Northrup School Storm water Operations and Maintenance Plan

Underground Infiltration System

MINNEAPOLIS PUBLIC SCHOOLS
ERICSSON ELEMENTARY
CAFETERIA AND CLASSROOM RENOVATION

UTILITY PLAN

NORTH
1
UTILITY PLAN
CI-0041.0

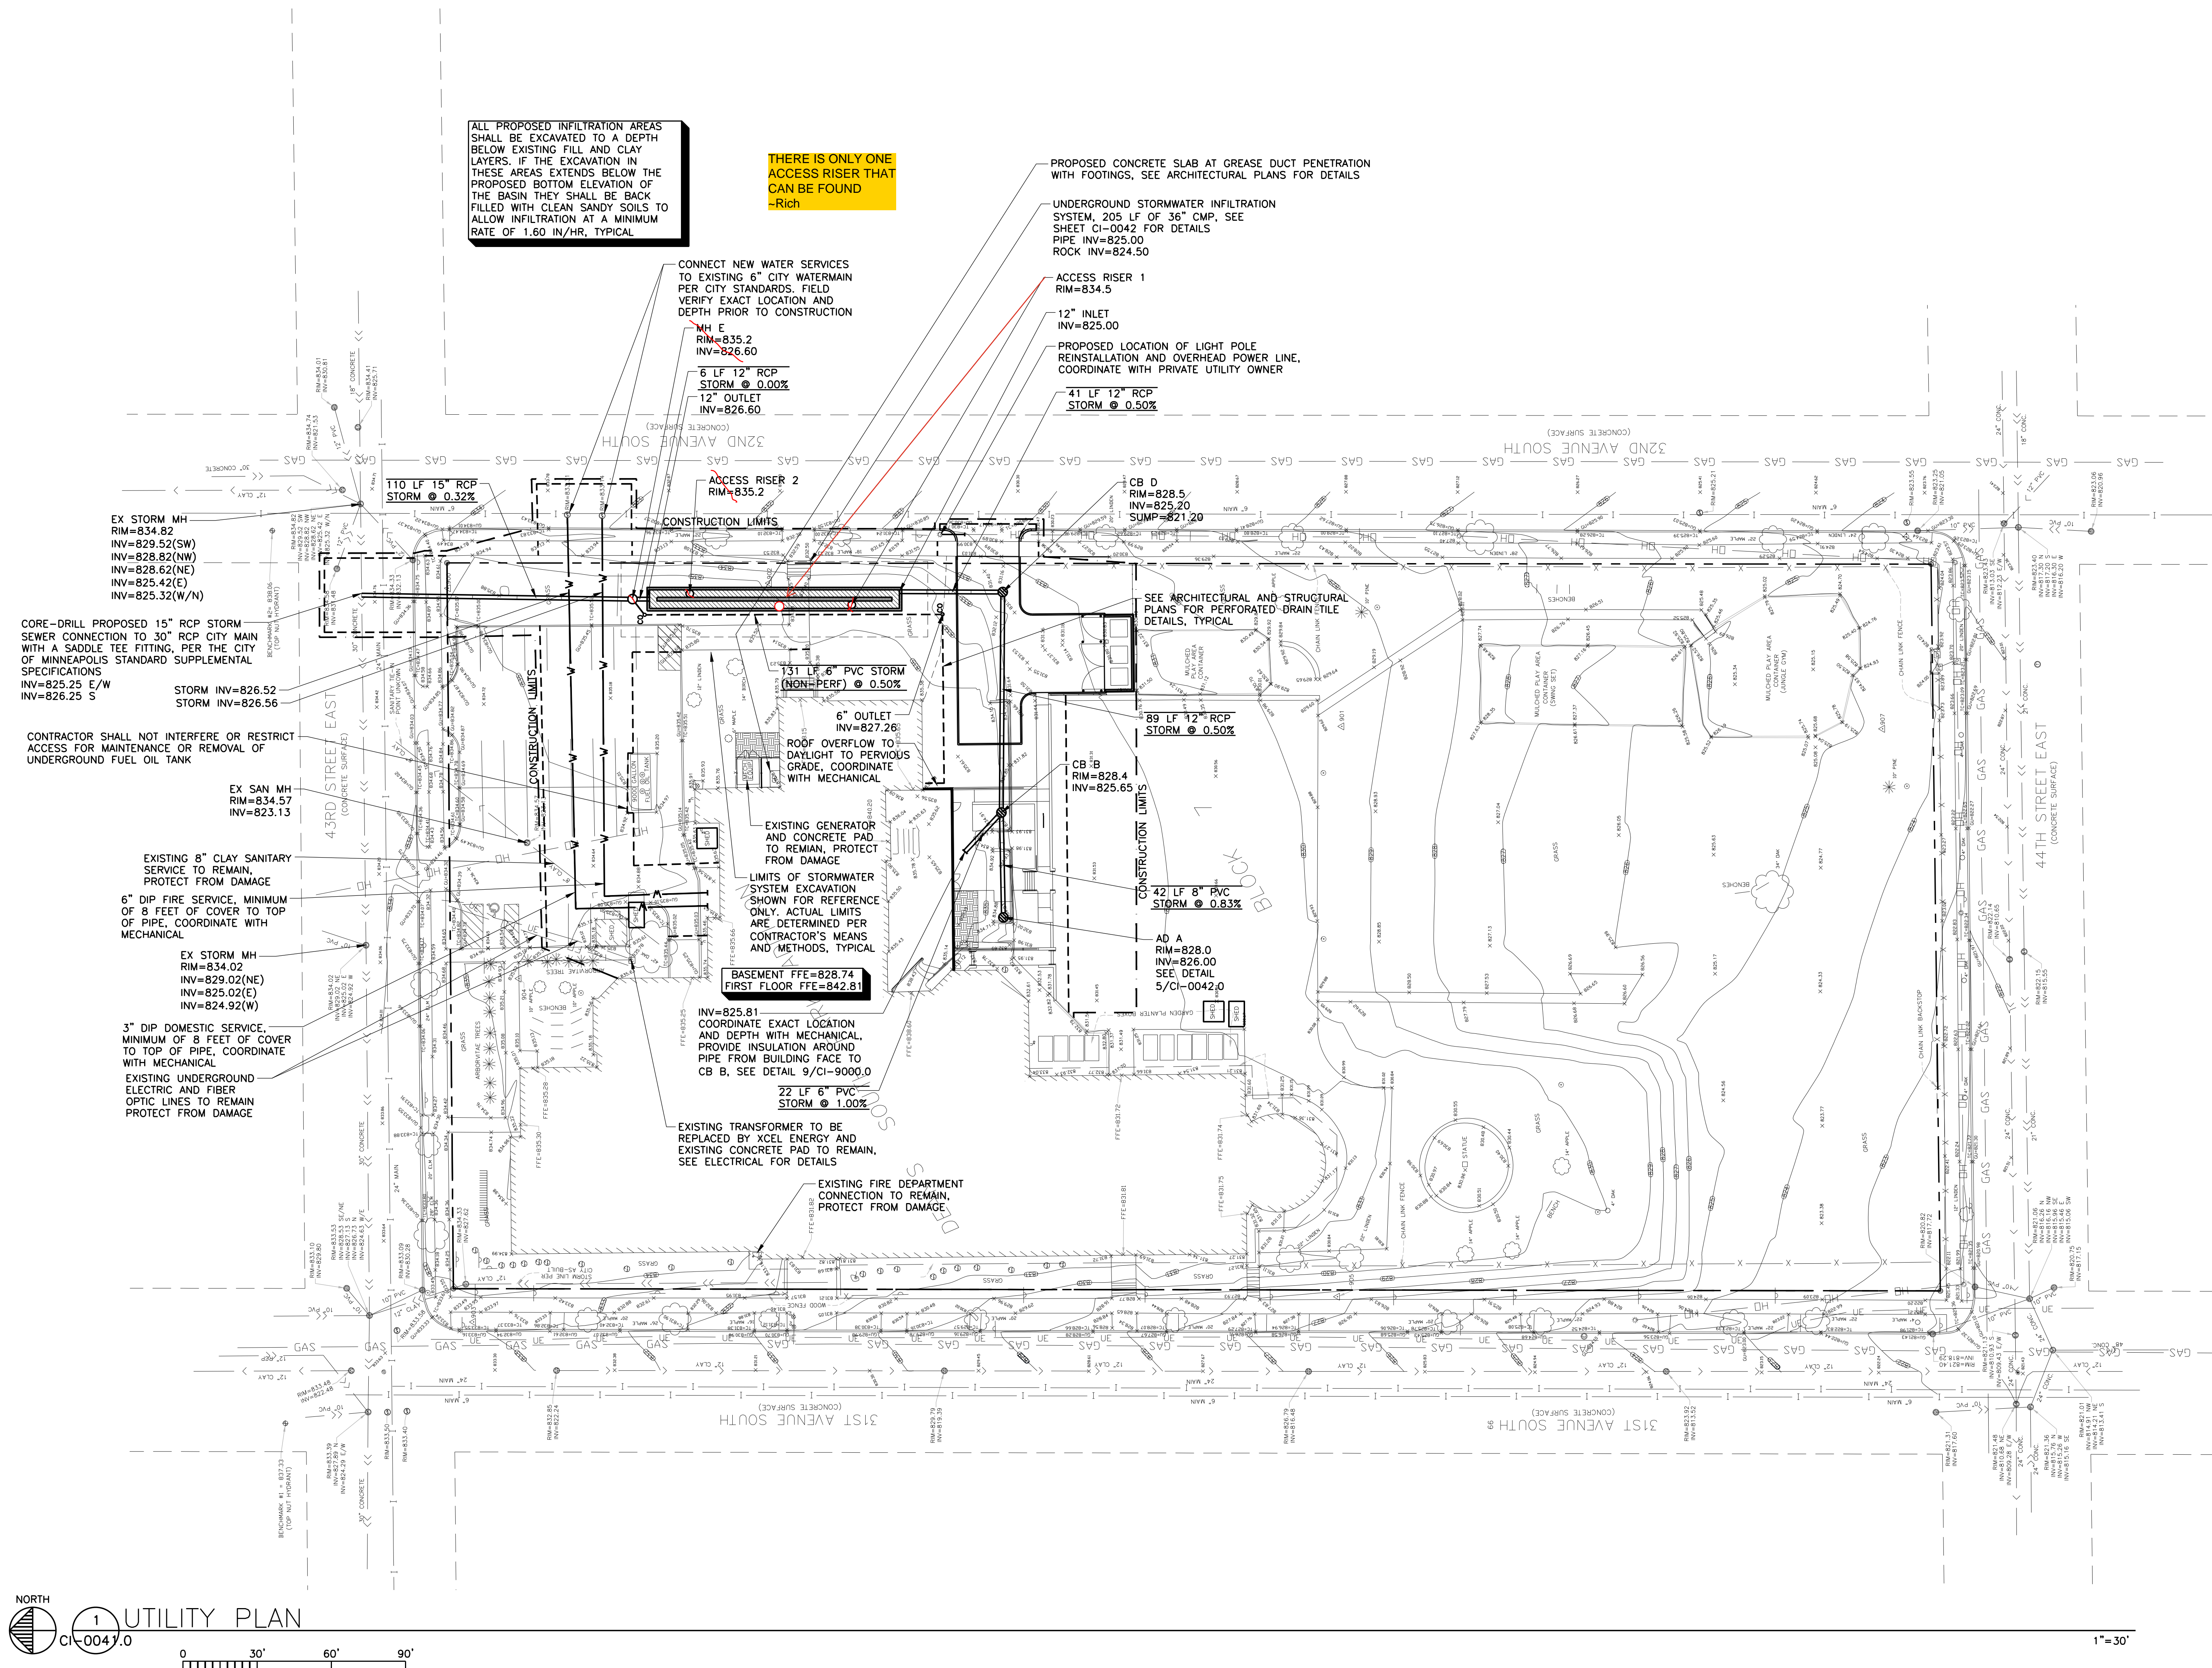
THERE IS ONLY ONE ACCESS RISER THAT CAN BE FOUND -Rich
